March 2, 2016

**Release Announcement: 6TB Western Digital Re-series Hard Drive Approved for Production.**

Image 1. SBB4 fan, fan speed DIP switches

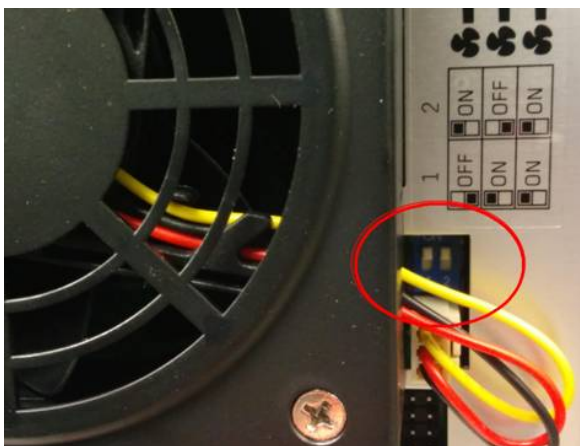
- A. 6TB hard drive is approved for use with Windows 7 operating system **only** when used in i3 PC-based Servers.
- B. 6TB hard drive is approved for video recording and storage **only** and is not approved for use as an OS drive.
- C. The owners of older i3 HVR/NVR units with the SBB4 hard drive enclosure, who wish to upgrade or add additional 6TB hard drives to their units, must ensure that **both** DIP switches on the SBB4 fan are in the upright (ON) position (see Image 1). This DIP switch position adjusts the SBB4 fan speed to the highest setting, allowing increased heat produced by 6TB drives to dissipate safely without causing damage to the unit. This SBB4 DIP switch position is already correctly set for all 6i/7i/8i/9i units purchased on or after June 1<sup>st</sup>, 2014
